SERVICE BULLETIN

B-018 May 13, 1999

SAFETY RECALL CODE 0810 - FRONT ISOLATOR MOUNT SYSTEM

Figure 1. Front Isolator Mount

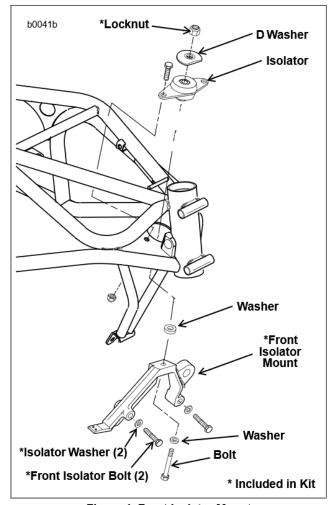
Buell Motorcycle Company has learned that certain 1997 and 1998 Buell motorcycles were built with an isolator mount system that could lose clamp load. Should this condition occur, it may allow the engine to move unexpectedly in the frame and cause an unintended distraction to the operator, which could result in an accident. Accordingly, Buell Motorcycle Company is conducting a voluntary recall campaign to formally recall all potentially affected motorcycles.

This condition will be remedied by replacing the front isolator mount system on all potentially affected vehicles.

- 8. Remove and discard two bolts and washers from left and right side of front isolator mount.
- 9. Remove front isolator mount from left side of motorcycle.

- Clean residual loctite from threads in engine with a suitable nonflammable solvent and dry with compressed air.
- Apply LOCTITE THREADLOCKER 271 (red) to threads of new front isolator mount bolts.
- Apply a thin film of clean HD 20W50 engine oil to both sides of **new** thick washers and to bottom of bolt heads. Exercise caution to avoid mixing oil on washers with loctite on bolts.
- 13. Position **new** front isolator mount and secure with two **new** front bolts with **new** thick washers. Tighten bolts to 60 ft-lbs (81 Nm) initially and then loosen each bolt one full turn. Tighten bolts again to 60 ft-lbs (81 Nm).
